COMBINED DEVELOPMENT APPLICATION - MATERIAL CHANGE OF 5.9. **USE - 4 DWELLING HOUSES & RECONFIGURING A LOT (2 LOTS INTO** 4 LOTS) - 69-73 MURPHY STREET PORT DOUGLAS

APPLICATION NO CA 2023 5316/1

Material Change of Use - 4 dwelling houses & **PROPOSAL**

6 June 2023

Figure 2 - Section Plan through dwelling 1

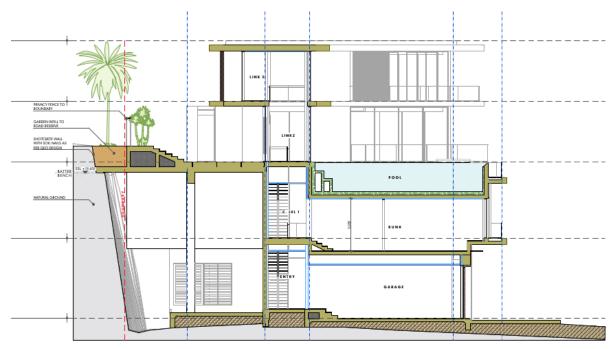
Stabilisation works are required to be undertaken in the road reserve of Murphy Street which has posed some challenges with respect to how the two rear dwellings address Murphy Street. Several sections are provided below which detail the building relationship between Murphy Street and the buildings.

The dwellings fronting Murphy Street will be setback approximately 3.5m at the Murphy Street road level with the elements of the building having reduced setbacks at lower levels. Part of the building have 0m setbacks on Murphy Street, however as these elements are below ground level and will not be seen, no issues are raised.

Figure 4. Vehicle entry within road reserve.

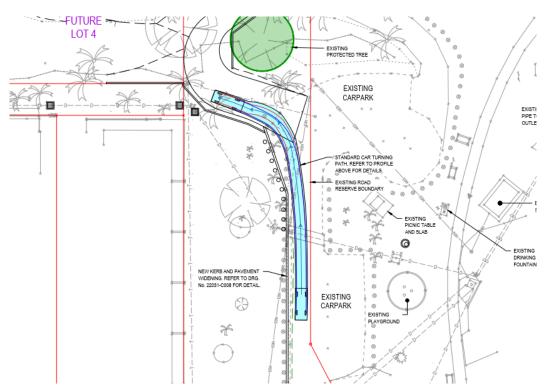
The driveway accessing the development is a single access driveway. Retaining walls have been implemented in order to reduce the earthworks footprint and to reduce the impacts on the large tree which is being retained. This treatment also allows for additional landscape treatments to be implemented.

A condition of the approval requires further detail to be provided regarding operating procedures regarding the control of a one-way entry and exit. Further design modifications maybe necessary. The Applicant is also required to confirm that the internal driveway is intended to provide for 2-way vehicle movements.

Figure 5. Driveway & Drainage Plan

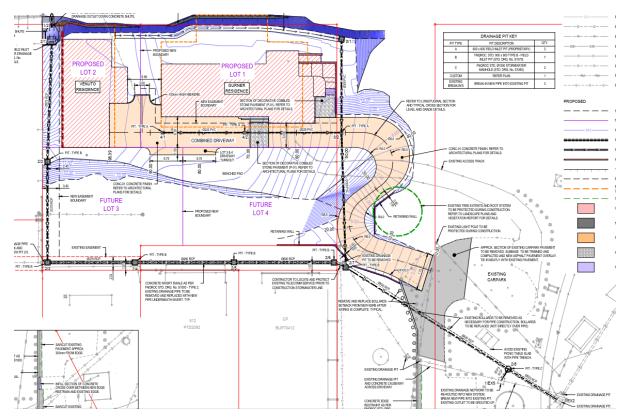
The drainage solution involves a new pipe system picking up the stormwater in Murphy Street and bringing that down in an underground piped network adjacent the western boundary, along the southern boundary and then into a new piped system across the unconstructed road reserve and park area to connect into the existing outlet on the beach.

All earthworks, driveway access, drainage, water supply and sewer works will be subject to the operational works approval process. An application for operational works is expected to be lodged soon given the engineering design for the development is quite advanced.

Figure 6. Watermain extension

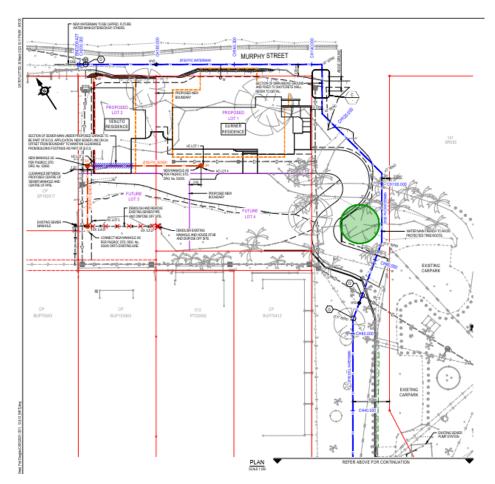
The augmentation of the existing water supply network is illustrated below. The new water main is consistent with conditions attached to the previous approval with respect to establishing a ring main from Macrossan Street to Murphy Street.

The installation of a ring main now ensures that the installation of the main does not conflict with works in the road reserve and it is a practical approach to have the works done now as part of the construction. The creation of the ring main also provides additional redundancy in the network.
